Lancaster County School District Amendment #1	Solicitation Number	202502	
		Solicitation Issue Date	07/30/24	
		Amendment Issue Date	8/12/24	
		Procurement Officer	Trevor Hammond, NIGP-CPP, CPPB (803) 416-8828	
		E-Mail Address	trevor.hammond@lcsd.k12.sc.us

DESCRIPTION: **Restrooms for BHS & LHS Baseball Fields**

Effective this date, this amendment forms part of the contract documents and modifies the original IFB

9 THRUST BLOCKING - TEE
C501 NTS

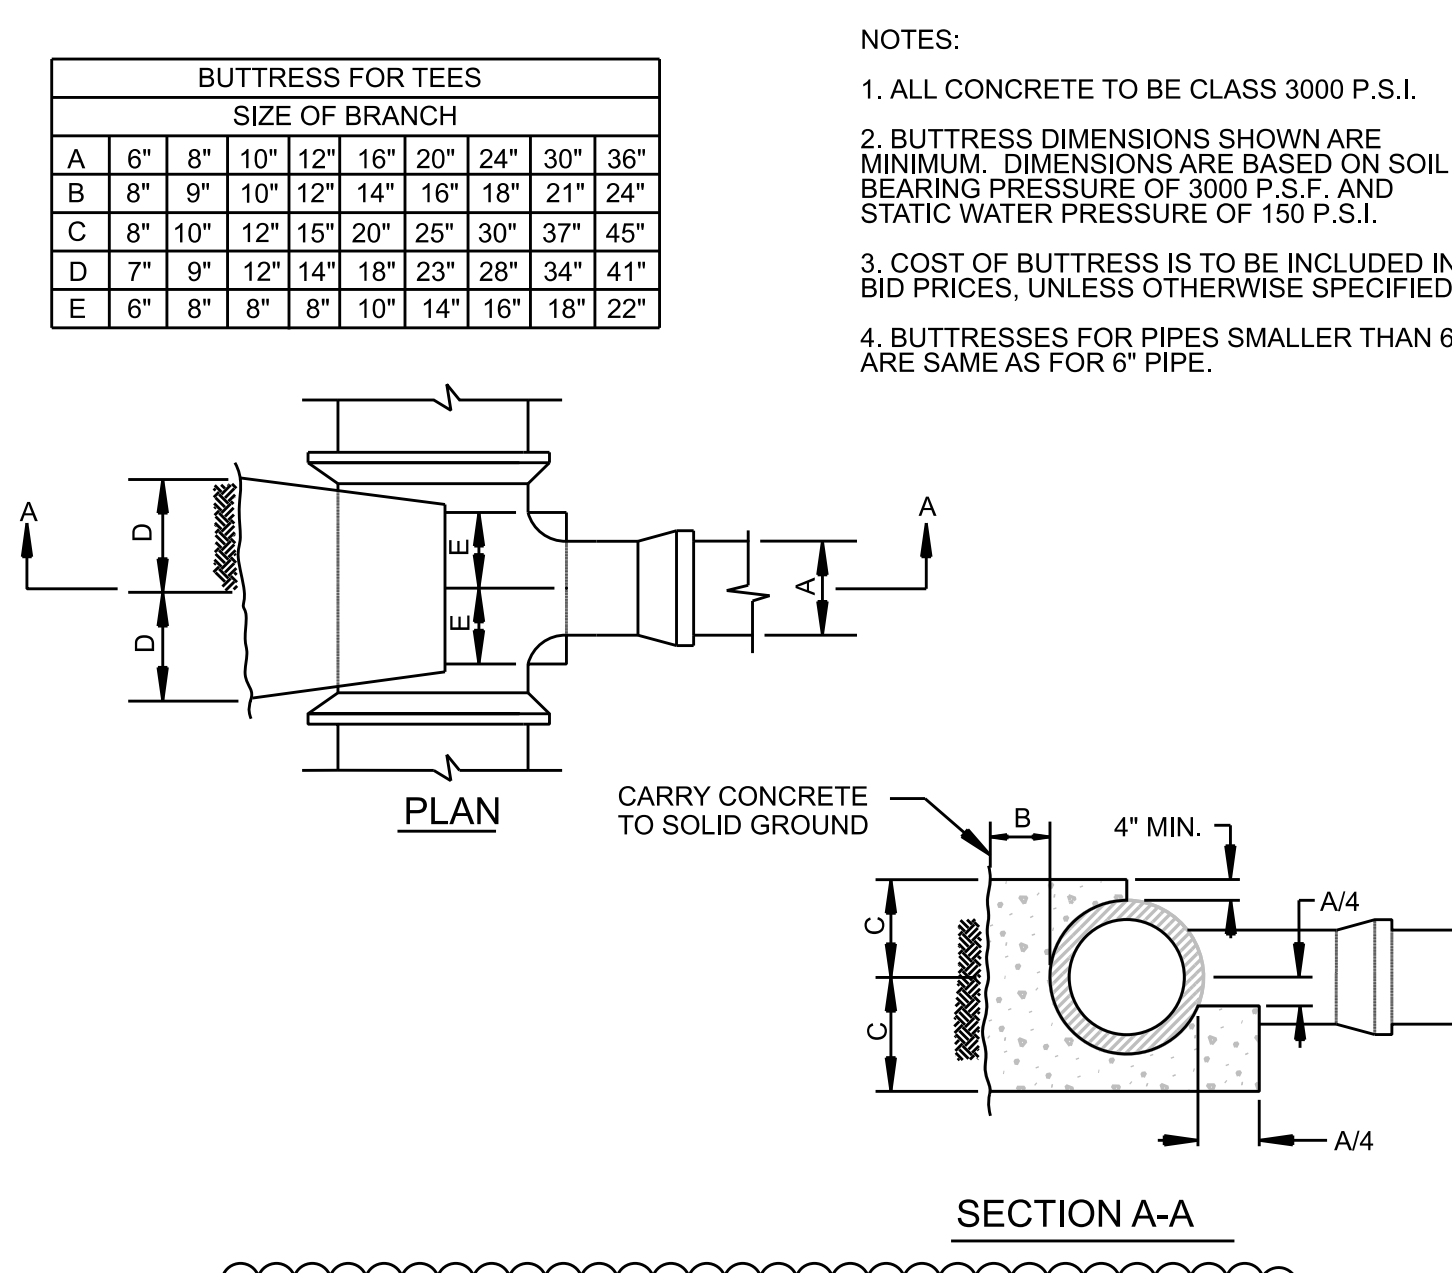
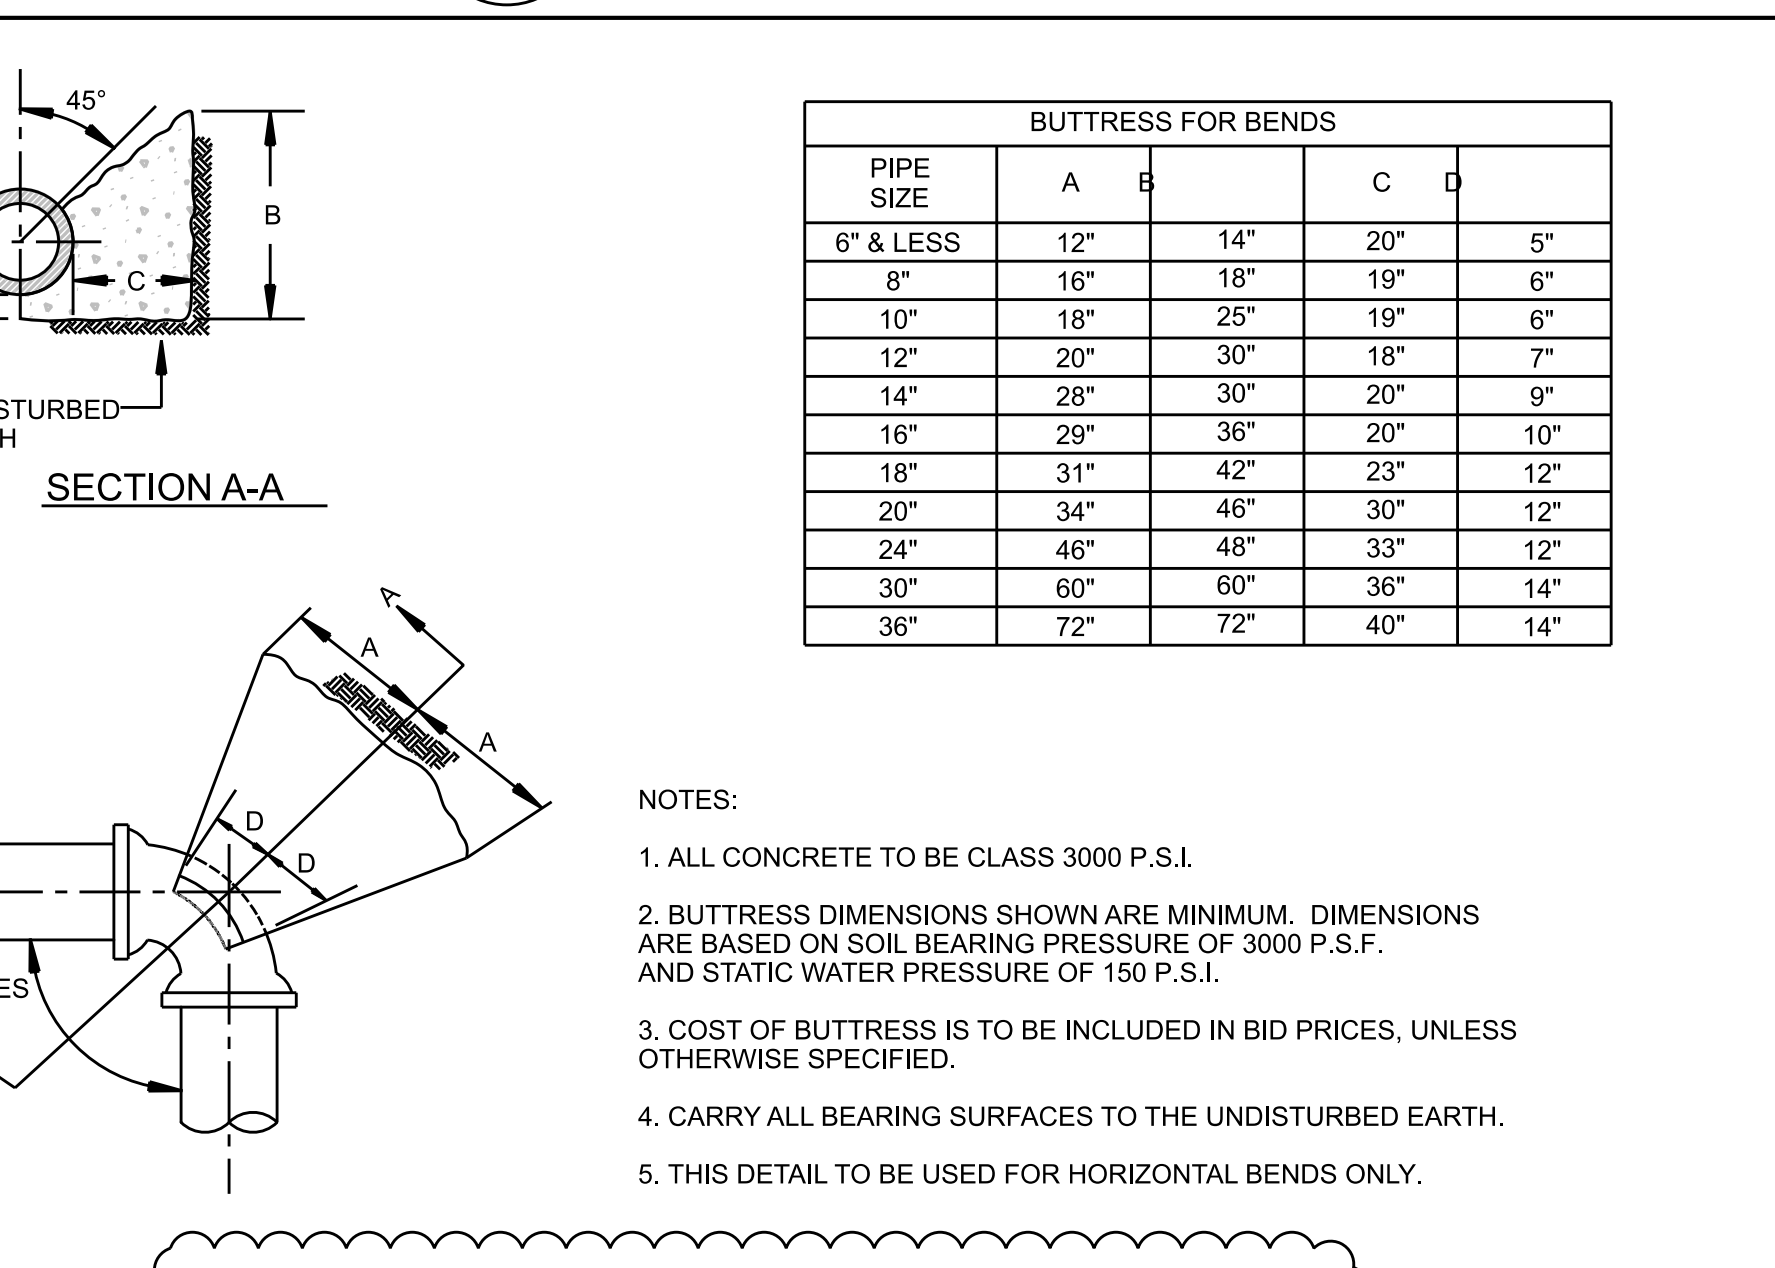
- C. Replace Sheet C501 with revised sheet C501 – Water & Sewer Details, included in the Attachments.
 1. 2-inch polyethylene C-901 water service line has been revised to a 2-inch PVC SDR-21 water service line.

2. 2-inch compression fittings have been revised to 2-inch fittings with blocking.
- D. Replace Sheet A-050 with revised sheet A-050 – Architectural Site Plan, included in the Attachments.
